# CCC Audit of Tavistock Place - Torrington Place trial. 7 Dec 2015

### **CCC recommendations on the St Pancras Bollards:**

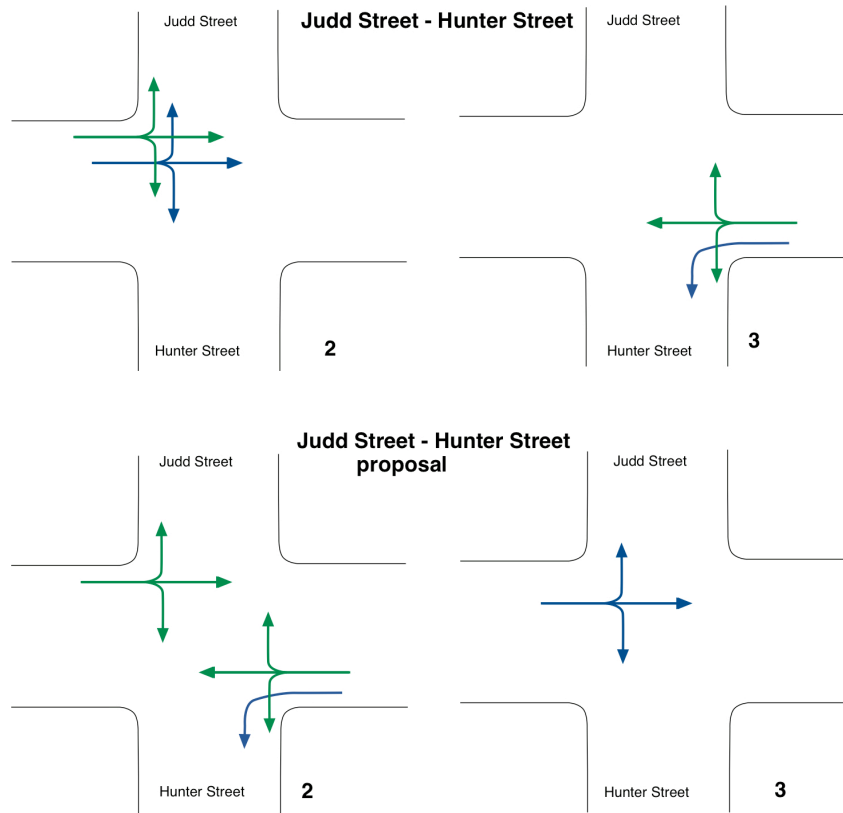
There is a pair of bollards at the entry to each section of the track (e.g. see the top photo on the right), the gap between them is only about 1.5m-1.6m.

The minimum recommended width for a cycle track is 1.5m on the ground (LCDS Fig 4.11), but more space is needed between vertical posts. For medium cycle flows, the width needs to be 2.2m.

For the safety and convenience of cyclists, the kerbside bollards should be removed everywhere. We understand that the intention is to prevent motor vehicles entering the track, but we believe that this solution is excessive, over-engineered and dangerous to cyclists and that signage will be sufficient. We have witnessed one cycle collision with a bollard and others have been reported.

See the photo on the left (with Byng Place ahead): this pair of bollards is redundant. The line demarcating the edge of the cycle track should lead to the solid island ahead of the bollards. The second photo on the right is at the junction with the one-way southbound Herbrand Street. No motor could be in a position to enter the cycle track here. The outside bollard is occupying too much of the cycle track and is effectively redundant.

1. Remove all of the kerbside St Pancras bollards;
2. Remove the pair of bollards east of Gordon Square and paint a continuous white line;
3. Keep bollards on the offside only where they perform a useful function of preventing vehicles over-running the track, especially at junctions.

## Junction at Judd Street/Hunter Street

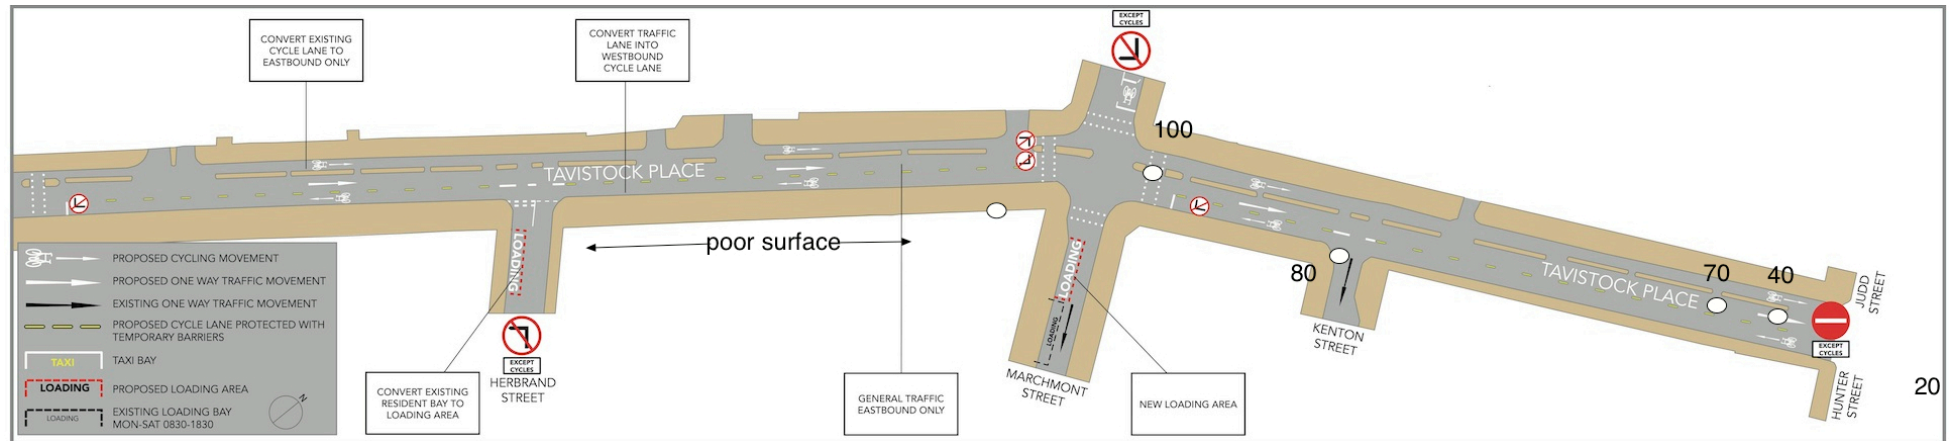
There is a risk of left hook for eastbound cyclists. Before the trial, cyclists moved out of the cycle tracks and used the feeder lane and ASL. We think the current arrangement is more dangerous than before because the segregation makes both motorists and cyclists think it is safe and because with the segregated lane and no ASL cyclists can't take up a protective road position.

The first figure on the left shows the existing stages 2 and 3 of the signals. It illustrates the potential left hook situation for eastbound cycles. For westbound cycles, the risk of left hook is eliminated by the very narrow road space inside the island as illustrated in the first photo on the right.

The second figure on the left shows CCC's proposal for stages 2 and 3 of the signals. Eastbound cycles turning right would merge with the left-turning westbound motors.

*Interim measure:* the second photo on the right shows the point where cycles used to move out of the cycle track into a feeder lane. CCC suggests that a proper ASL be constructed in front of the stop line that has already been set back and that the kerb be removed to provide

a mandatory feeder lane from the cross-over point. Elephants footprints across the junction.

1. Interim measure: provide a feeder lane and ASL together with elephants footprints.
2. Solution: alter signals to allow eastbound cycles to proceed with westbound motors.

## Tavistock Place Audit: East

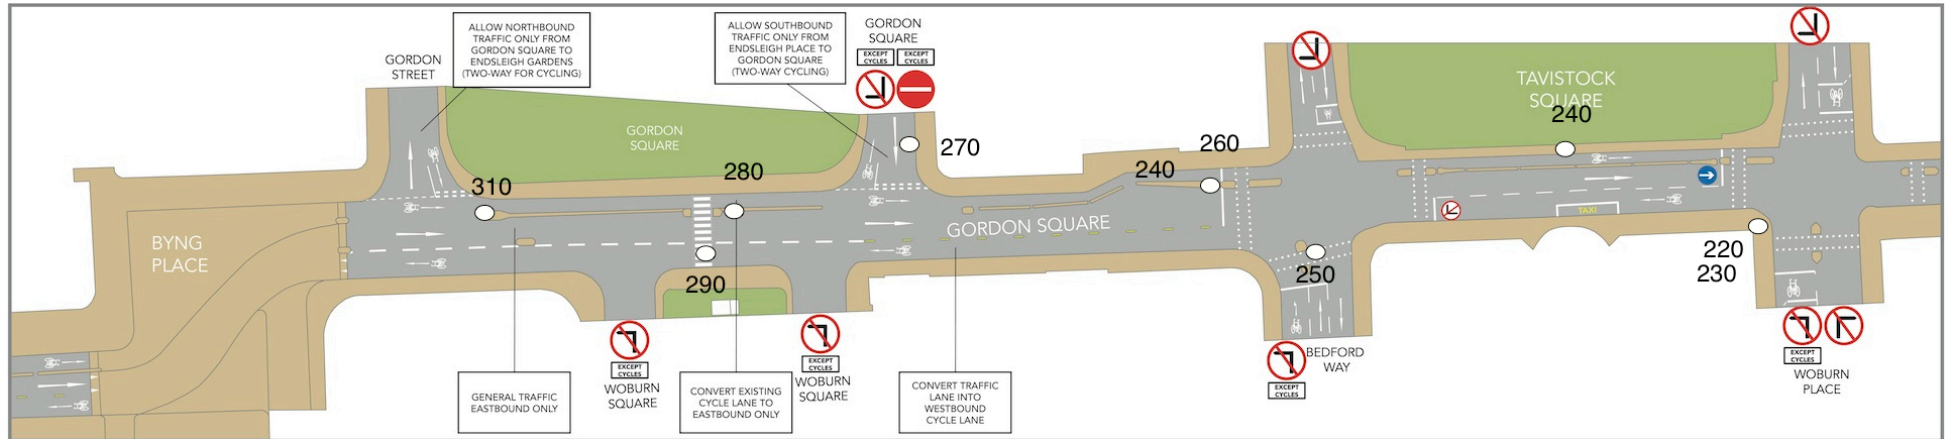
20: Damaged SRB. 70: Obscured signs.

40: Incorrect sign (photo on top right) also at 310 (on next map see photo <https://flic.kr/p/BPYuw1> )

100, 280, 310 and elsewhere: General query about the white arrow on blue circle sign on SRBs (see photo on left and map on next page for locations 280, 310).

100: No left turn sign is confusing for cyclists. The profusion of SRBs is very ugly: do we need them all?

80: Blue one-way arrow needs to be turned to face anyone trying to enter Kenton Street.

100: there is no forward signal head, so the signal can't be seen from the front of the ASL. We suggest a low-level cycle signal.

## Tavistock Place Audit: Middle

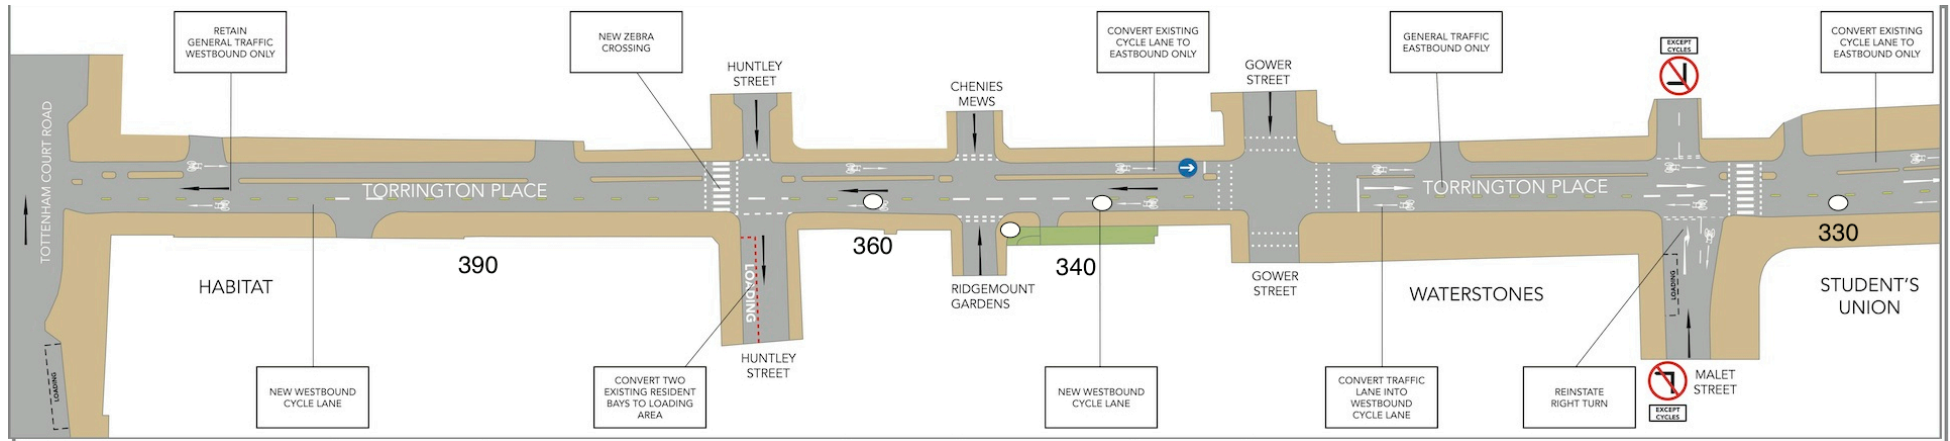
220, 260: Currently eastbound cycles are forbidden to turn left into Tavistock Square (E and W) because this move would conflict with the pedestrian green signal. There are others e.g. right turn from Judd Street.

230: Need solid white line, icons and arrows. (See photo <https://flic.kr/p/BiS1QV> which shows just a white line.

250: Need painted cycle lane across the junction with Bedford Way (photo on right). EB approaching junction with Bedford Way, suggest RH Motor Vehicle lane is clearly marked for Right Turn only to avoid confusion.

260: Blue sign needs to be removed ([photo on left](#))

270: The currently covered *No Entry* sign appears to lack an Except Cycles subplate.

**SRBs:** 280, 310: see general query about the white arrow on blue circle sign (on previous page)

240: Sunken gully. Cyclists swerve to avoid this.

290: damaged surface on cobbles on both sides of the zebra crossing on Gordon Square (photo: <https://flic.kr/p/BiS36k>)
